## DOCUMENT CHANGE REQUEST

Title: Transistors Low Power NPN, based on types 2N3498 thru 2N3501

Number: 5201/013

ESCC Detail Specification No. 5201/013

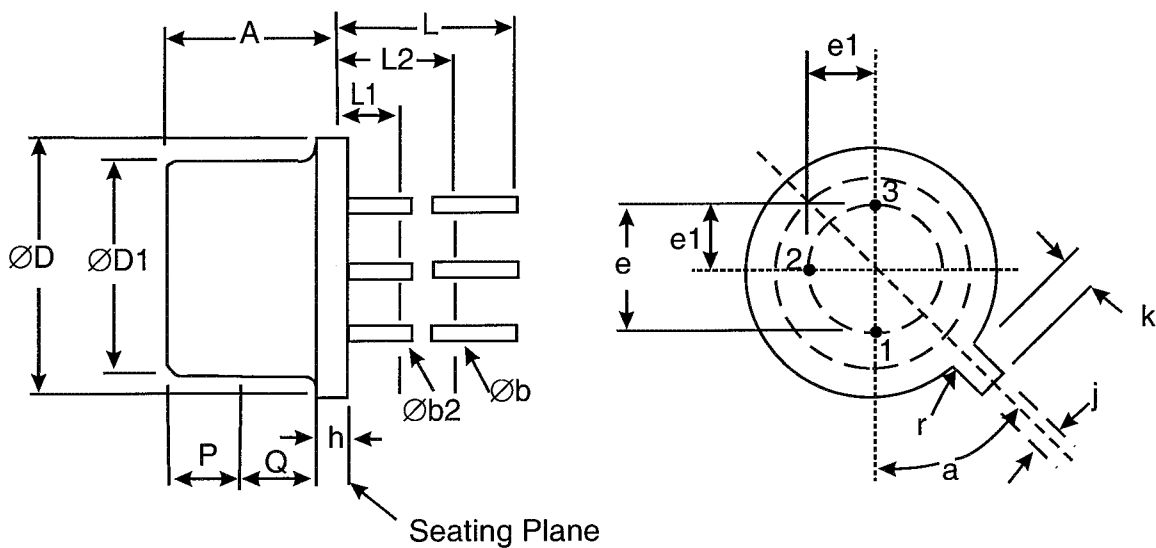
Update the Maximum Ratings table (see the attachment for details) so that this detail spec is clear, complete and the content and format is in-line with other detail specifications for similar Part Types.

Page 6: Original Note 2 to Maximum Ratings – add “, and any handling,” between “testing” and “performed”.

Characteristics	Symbols	Maximum Ratings	Unit	Remarks
Collector-Base Voltage	$V_{CB0}$	150	V	Over entire operating temperature range
Collector-Emitter Voltage	$V_{CE0}$	150	V	
Emitter-Base Voltage	$V_{EB0}$	6	V	
Collector Current	$I_C$	300	mA	
Power Dissipation	$P_{tot1}$	1	W	At $T_{amb} \leq +25^{\circ}C$ <del>Note 1</del>
	$P_{tot2}$	5	W	At $T_{case} \leq +25^{\circ}C$ <del>Note 1</del>
Operating Temperature Range	$T_{op}$	-65 to +200	$^{\circ}C$	Note 1 & 2
Storage Temperature Range	$T_{stg}$	-65 to +200	$^{\circ}C$	Note 1 & 2
Soldering Temperature	$T_{sol}$	+260	$^{\circ}C$	Note 2

1. ~~For  $T_{amb}$  or  $T_{case} > +25^{\circ}C$ , derate linearly to 0W at +200 $^{\circ}C$ .~~
1. ~~For Variants with tin-lead plating or hot solder dip lead finish all testing performed at  $T_{amb} > +125^{\circ}C$  shall be carried out in a 100% inert atmosphere.~~
2. Duration 10 seconds maximum at a distance of not less than 1.5mm from the device body and the same lead shall not be resoldered until 3 minutes have elapsed.
